Permit Type	Permit Number	Opened Date
Building/Residential/Misc/Tanks	B22004543	12/16/2022
Description of Work		
SFD/INSTALL (1) UNDERGROUND 500 PROPANE TANK AND RUN LINE TO HOUSE

12/19 - permit on hold, 1p tank must be at least '50' from well box, emailed Lou Ann from Dixie Land.

PROJECT:		MYRTUE PROPERTY LOT 31	
LOCATION:		TAX MAP: 10, GRID: 24, PARCEL: 225, ZONED: RC-DEO 1910 DAVIS BRANCH RD. WOODSTOCK, MD 21163 6TH ELECTION DISTRICT, HOWARD COUNTY, MD, TAX ID 352668	
TITLE:		BUILDING PERMIT PLAN	
HOUSE TYPE:		CUSTOM - KEYSTONE HOMES	
DATE:	DECEMBER, 2021	PROJECT NO.	2099
SCALE:	AS SHOWN	DRAWING	1 OF 2

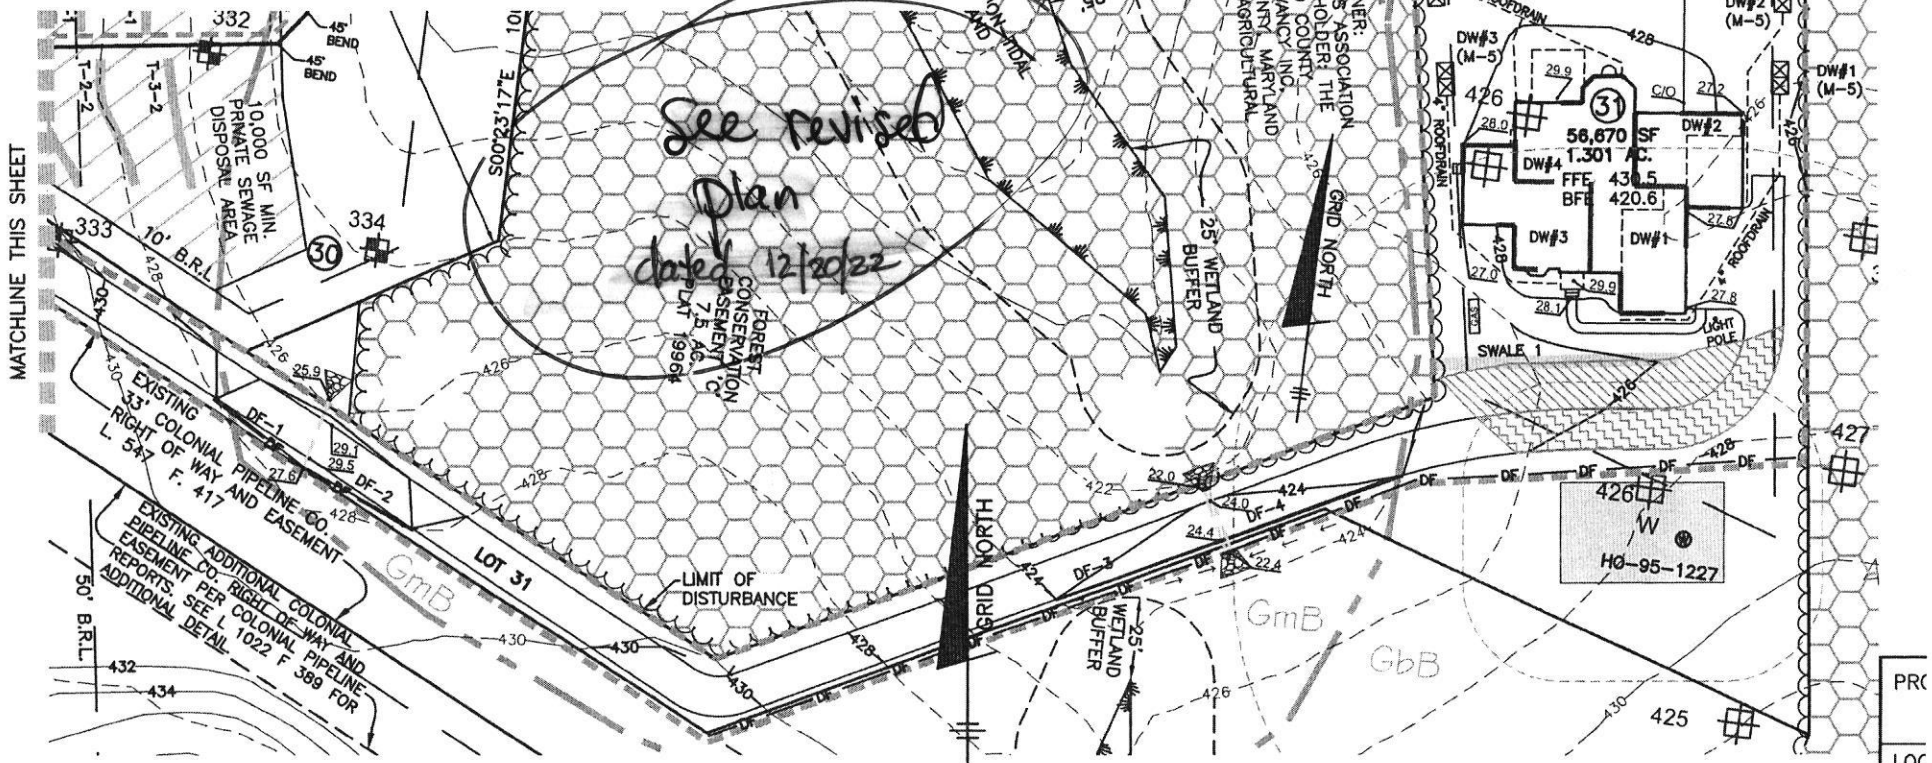
*Take 10x4'
30' off house
80' off well
150' off septic
15' off Light
95' off left
225' off Rear
115' off Front*

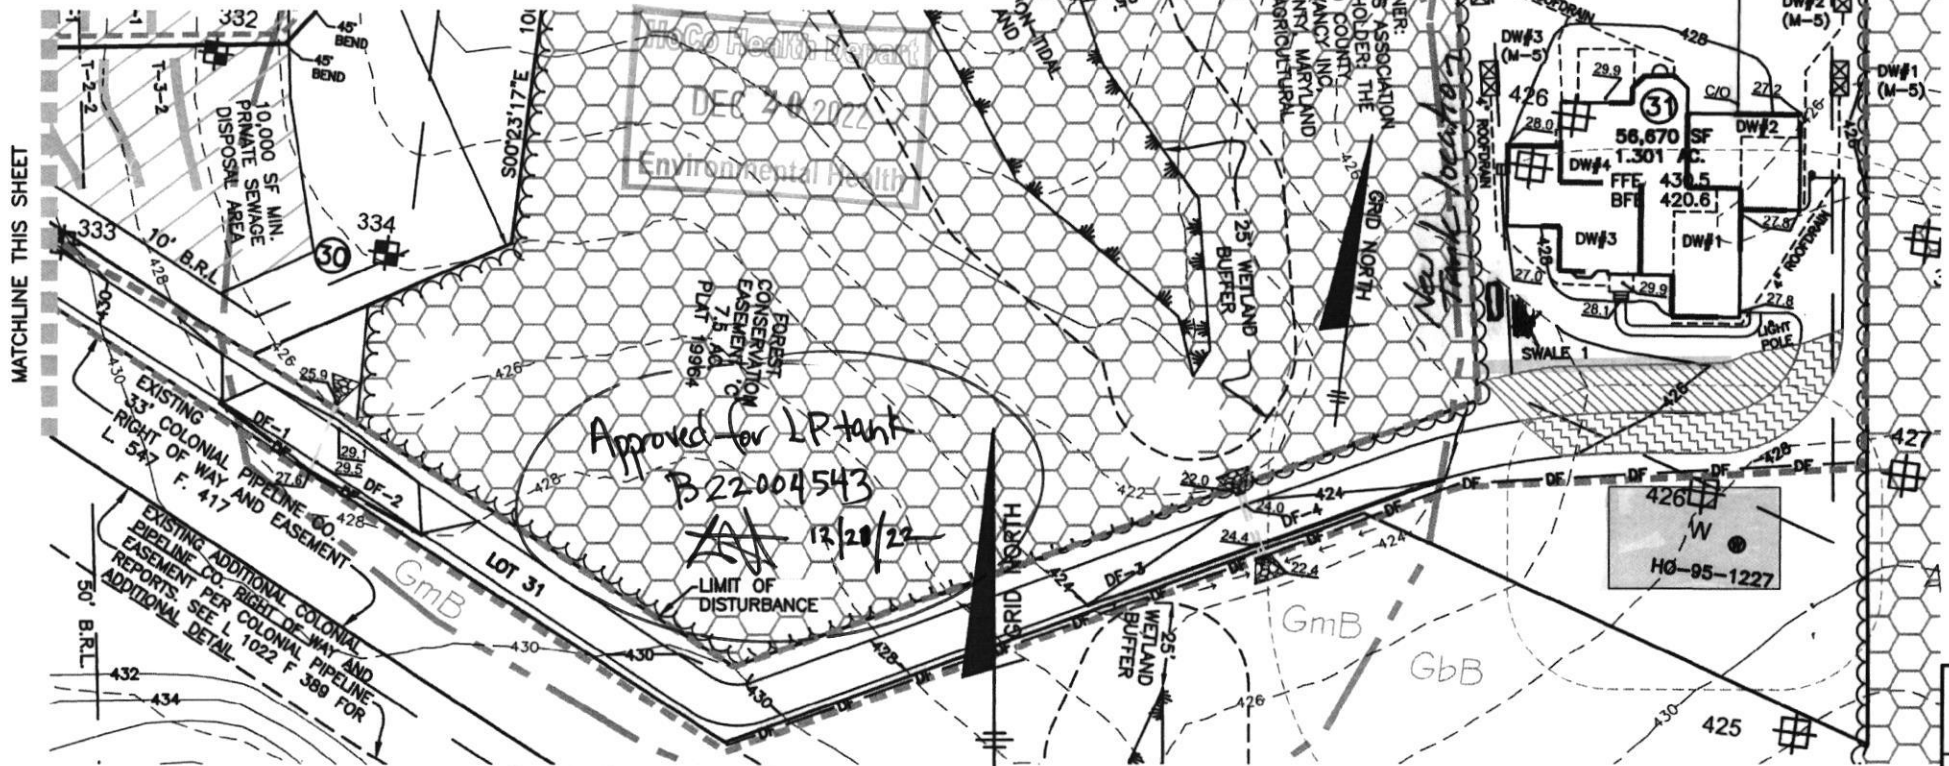
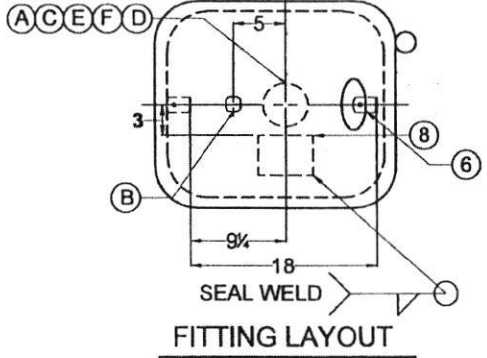
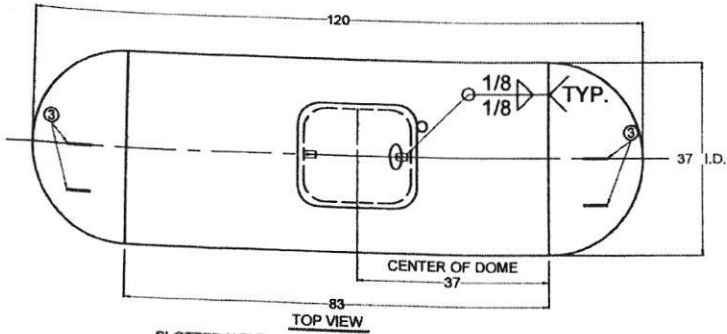
Tank 10' x 4'
20' off house
95' off well
105' off septic
15' off left
225' off Rear
115' off Front

★ MOVED TANK 10' Back toward left Property

Approved for LP tank
B22004543
12/20/22
